SOUTH AYRSHIRE COUNCIL

LOCAL REVIEW BODY

NOTE OF CURRENT POSITION

Site Address:	63 GREENFIELD AVENUE, AYR
Application:	23/00189/APP ALTERATIONS AND EXTENSION TO DWELLINGHOUSE

REV.	DATE	DESCRIPTION
CLIENT MR & MRS R. HOWAT		
PROJECT ALTERATIONS AND EXTENSION AT 63 GREENFIELD AVENUE DOONFOOT, AYR		
TITLE GROUND FLOOR PLAN, CROSS SECTION AND REAR ELEVATION - AS PROPOSED		
ORG. SCALE 1:100 @A4	ORG. NO. 2023-01-002	REVISION NO.

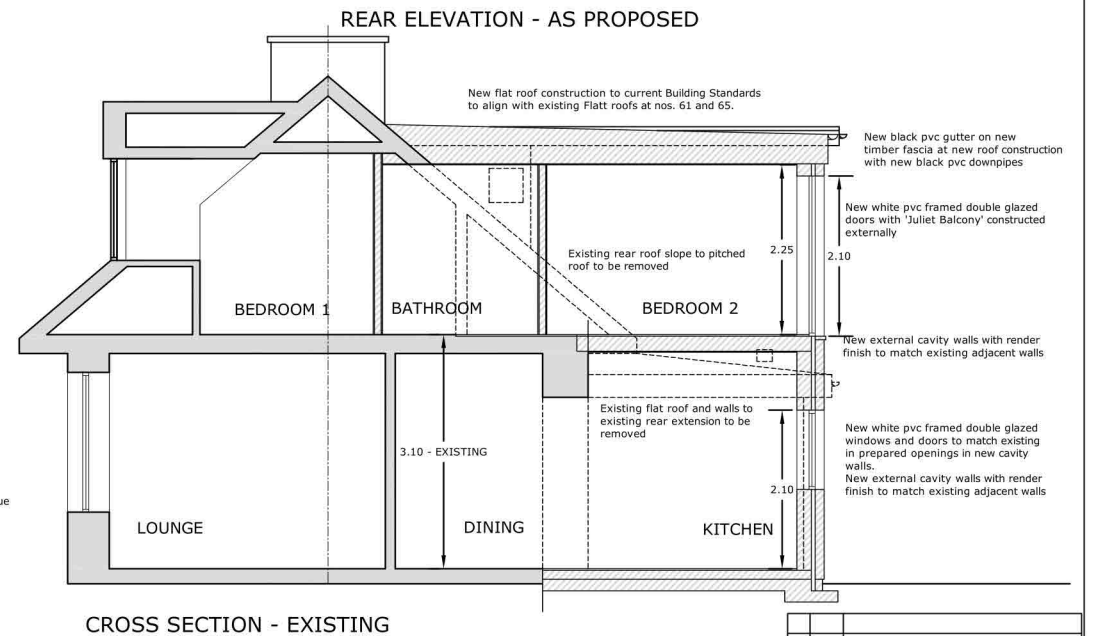
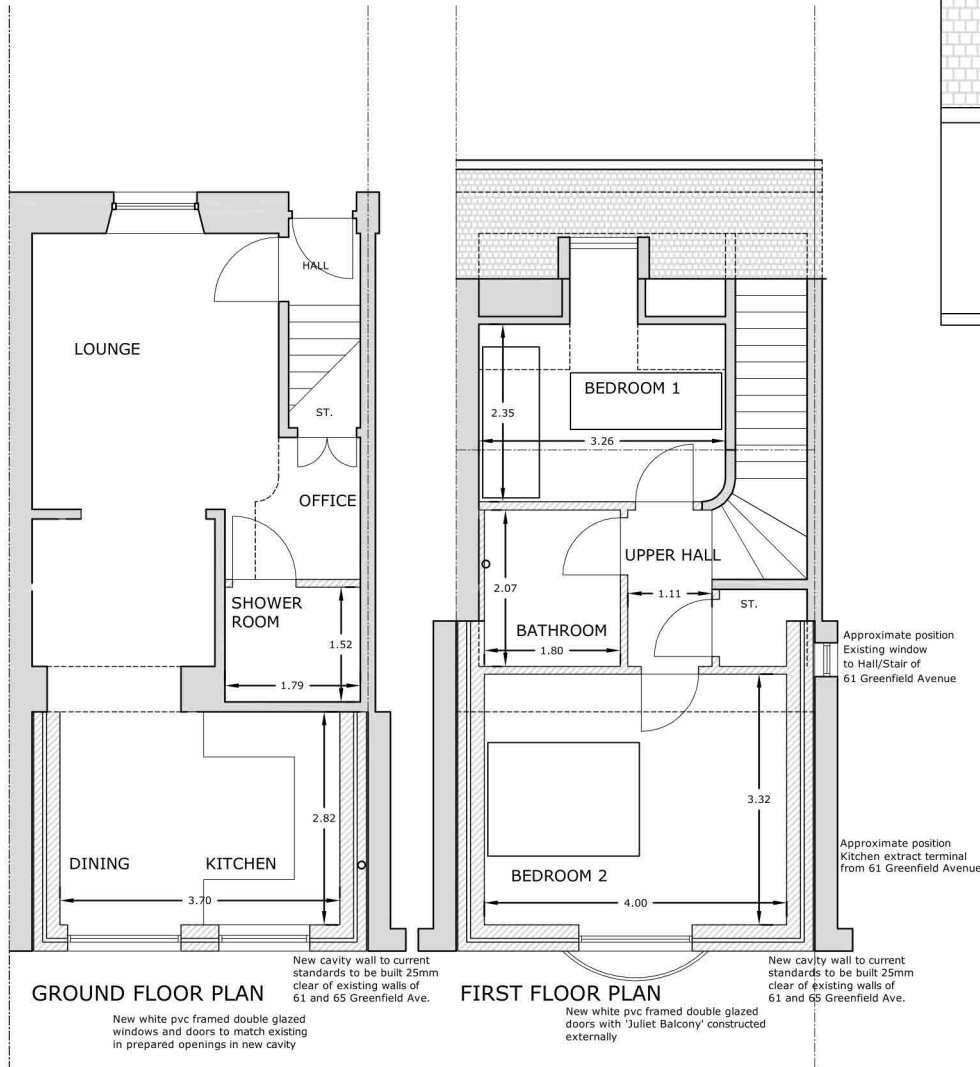
Plan indicates roof is aligned to existing flat roofs but not attached with a 25mm gap running on each side. This will allow an ingress of water and debris which would affect existing walls through dampness. There is no drainage or waterproofing identified and the gap means there is no facility for maintenance should such issues arise. Attaching the roofs to prevent this would require permission which has neither been sought nor given.

From the plans there is uncertainty regarding the existing window on the upper landing of number 61. I can only assume Mr Howat, plans to block my window up, with the proposed extension. This would cause much concern in my property-

Connection between roofing at 61 and 63, no reference has been shown as to how this connection would be constructed. Severe disruption to the old buildings and chimney heads could give added problems that have not been considered.

The proposed plans for the build, show a gap of 25mm on either side, of the extension. I feel this gap could cause severe concern-
